**A-404**

**PROPOSED**

72nd STREET AND COLLINS CORNER - NORTH FACADE

SOUTH BUILDING ELEVATION | 1  
SCALE 1/8"=1'-0"

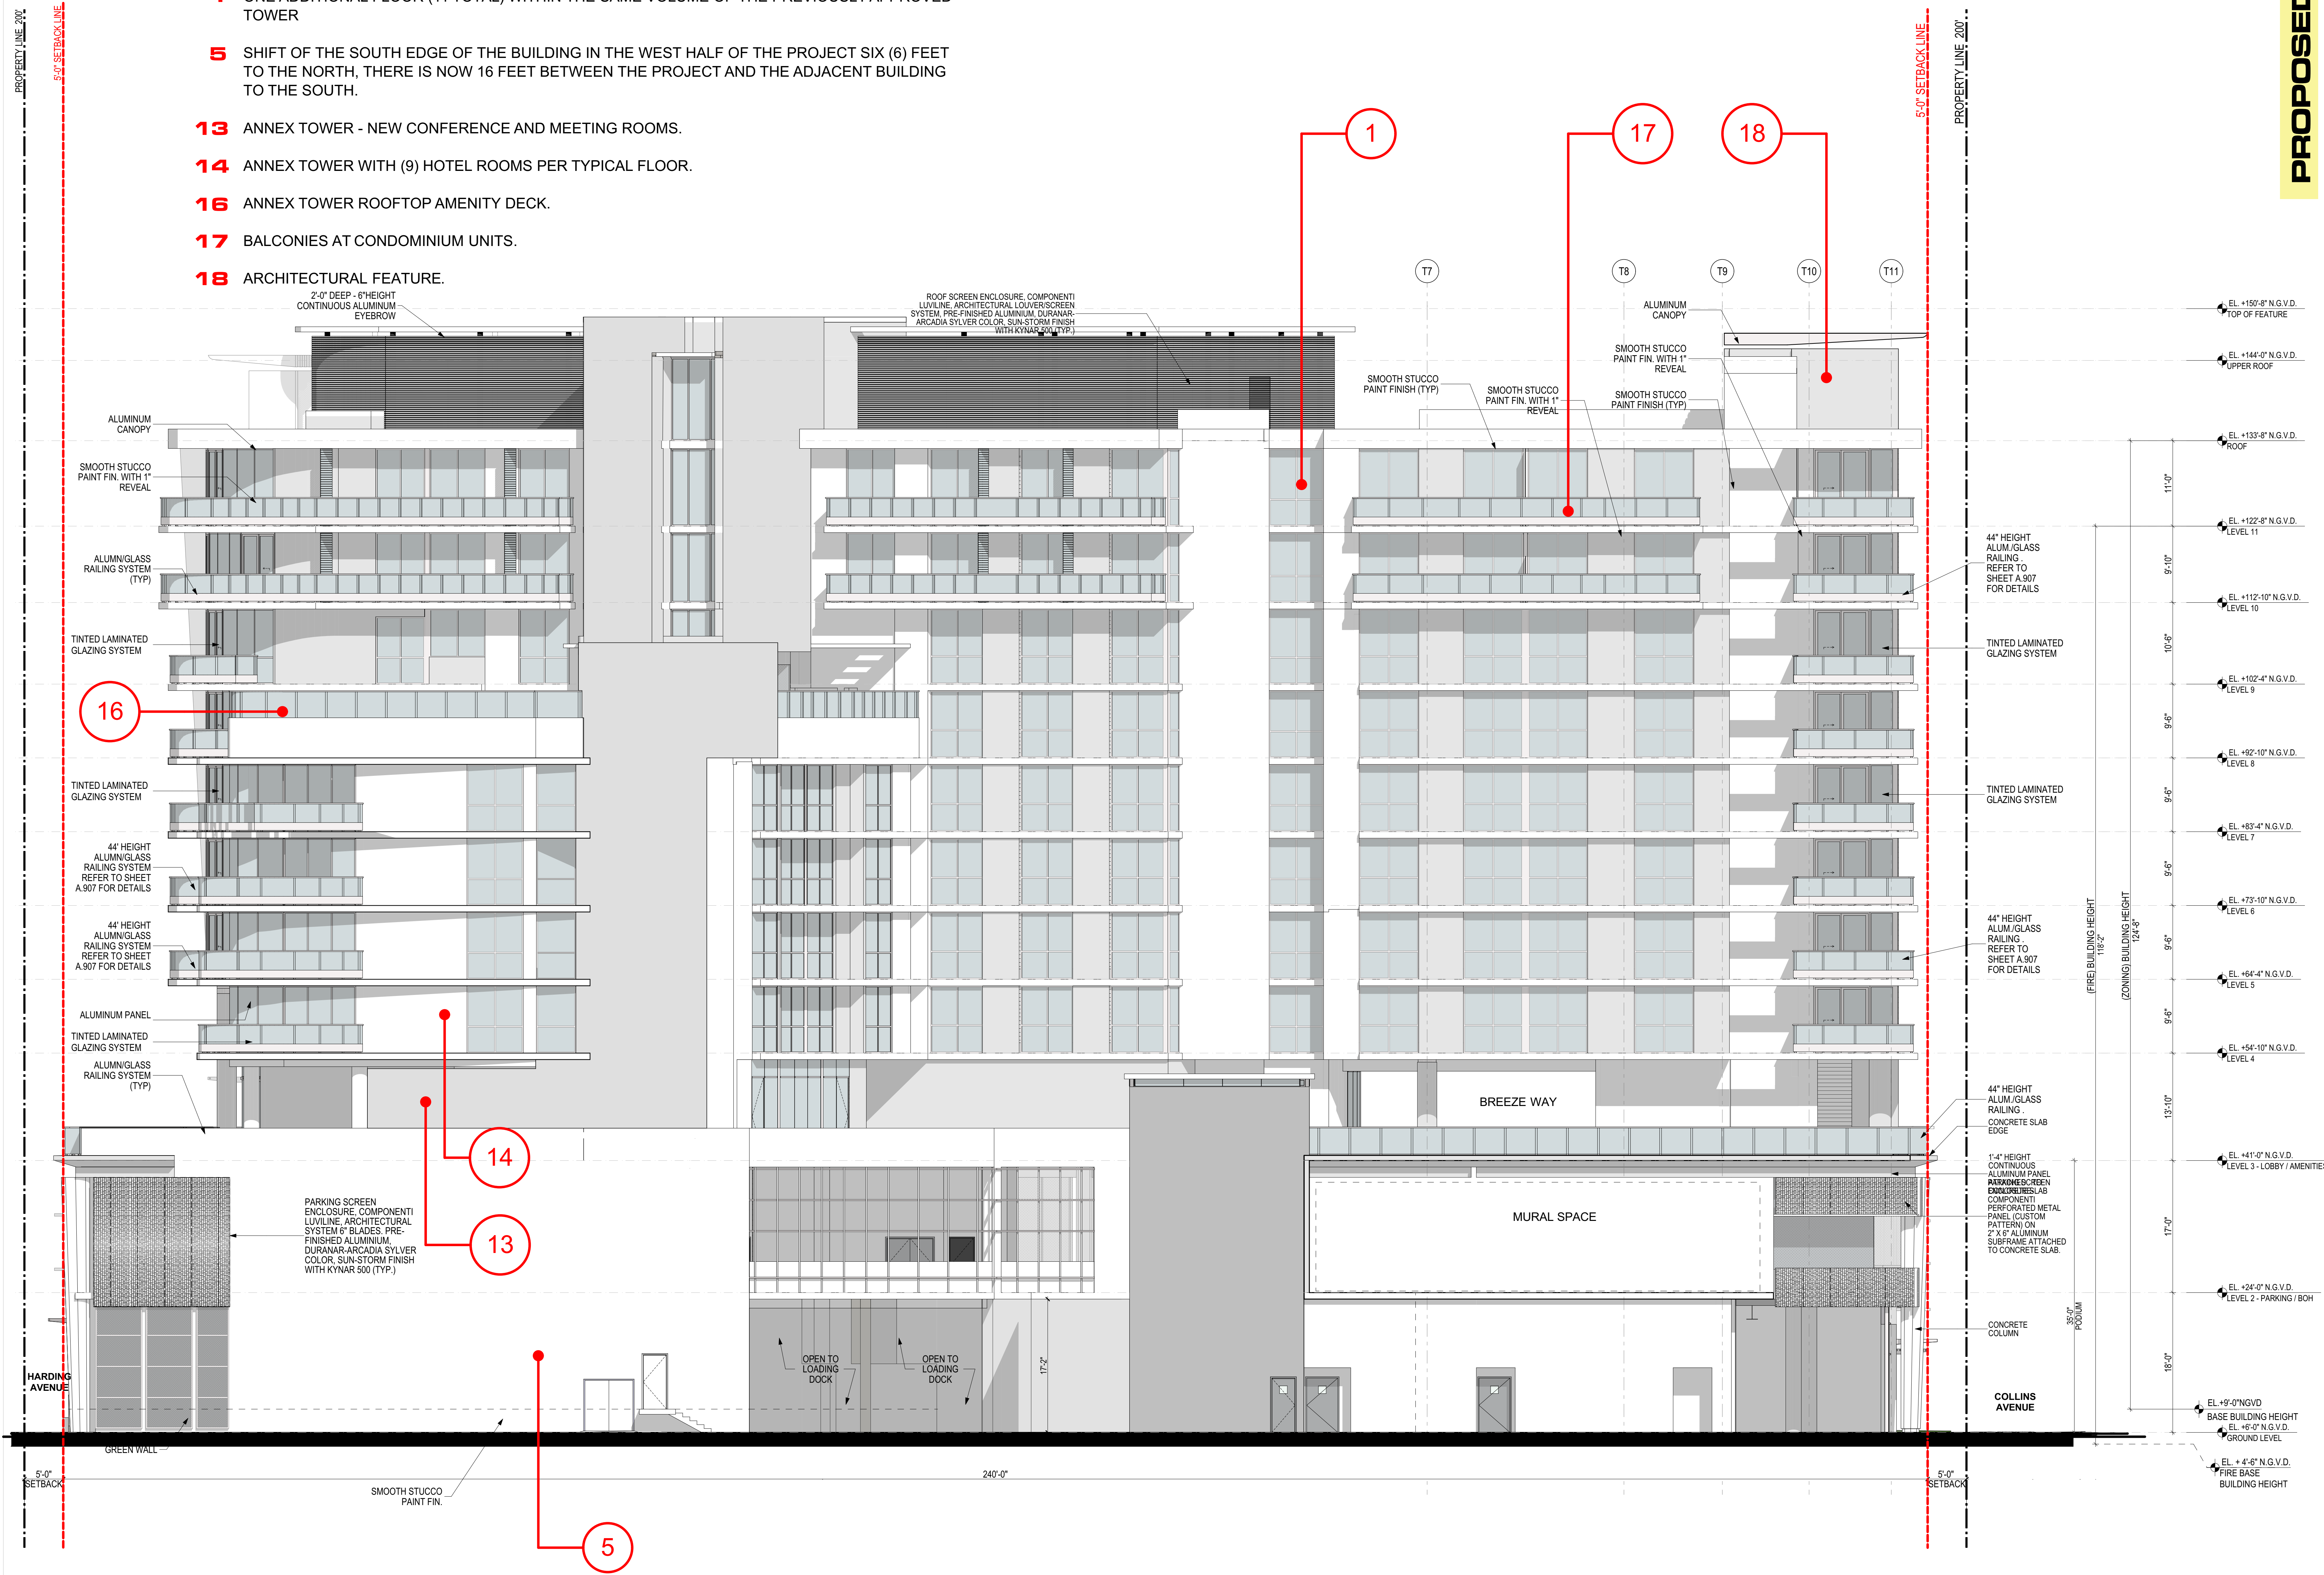
- 1 ONE ADDITIONAL FLOOR (11 TOTAL) WITHIN THE SAME VOLUME OF THE PREVIOUSLY APPROVED TOWER
- 5 SHIFT OF THE SOUTH EDGE OF THE BUILDING IN THE WEST HALF OF THE PROJECT SIX (6) FEET TO THE NORTH, THERE IS NOW 16 FEET BETWEEN THE PROJECT AND THE ADJACENT BUILDING TO THE SOUTH.
- 13 ANNEX TOWER - NEW CONFERENCE AND MEETING ROOMS.
- 14 ANNEX TOWER WITH (9) HOTEL ROOMS PER TYPICAL FLOOR.
- 16 ANNEX TOWER ROOFTOP AMENITY DECK.
- 17 BALCONIES AT CONDOMINIUM UNITS.
- 18 ARCHITECTURAL FEATURE.
